COPE Report Bergmanianum Building (Radboud University)
Adress: Houtlaan 4, 6525 XZ Nijmegen, Netherlands

Report of [REDACTED] date of visit 17/04/2024
Participants: [REDACTED] (Facility Manager Radboud University),
[REDACTED] (Aon Account manager)
[REDACTED] (Aon risk engineer)
[REDACTED] (Chubb Risk Engineer, writer of this report)

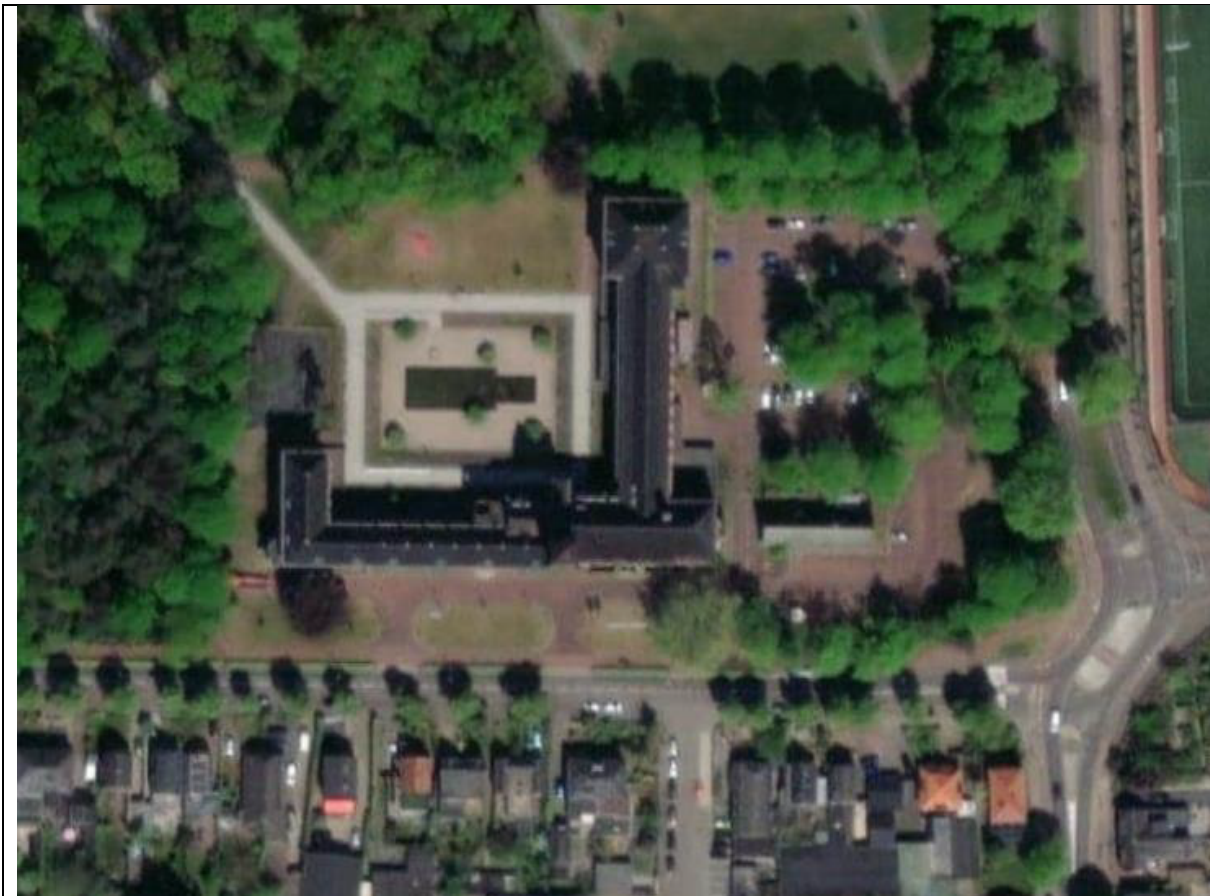
Server: As mentioned above there is a kind of server constructed in the attic, but not fire retardant separated and not provided with detection. The installation looks amateurish and is classified as a potential ignition source.

Op de zolder is zeer provisorisch een soort server kast gebouwd (zie foto). Voor een houten zolder met een houten vloer zien wij dergelijke apparatuur als van een mogelijke ontstekingsbron waarbij een brand zich kan uitbreiden tot de gehele zolder. Ontstekingsbronnen op zolder dienen zo veel mogelijk voorkomen worden. Daarom wordt met klem geadviseerd de apparatuur te verplaatsen naar een onbrandbare ruimte of de kast aan alle zijden (dus ook de vloer en het plafond) te omkleden met 60 minuten brandwerende scheidingsen (bijvoorbeeld dubbele gipsplaat) en de ruimte te voorzien van branddetectie. Uiteraard dienen kabeldoorvoeren brandwerend afgesmeerd te worden door een professionele organisatie.
